Date	May 20th 2013
Object	Safety Warning 2013/04 WALIBI LITE, WALIBI², EVASION²

## Replacing reserve parachute pocket elasicated cords

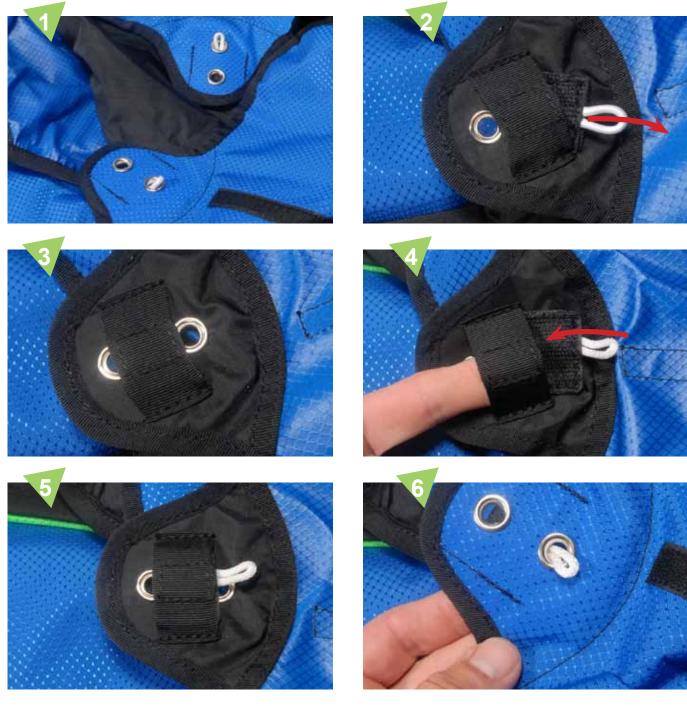
The reserve parachute pocket elasticated cords could become weakened by the stitched line holding them in place. To avoid and prevent any premature wearing and risk of tearing of the aforementioned elasticated parts, we will suggest you to replace them by the cords included with this correspondence.

Replacement set :
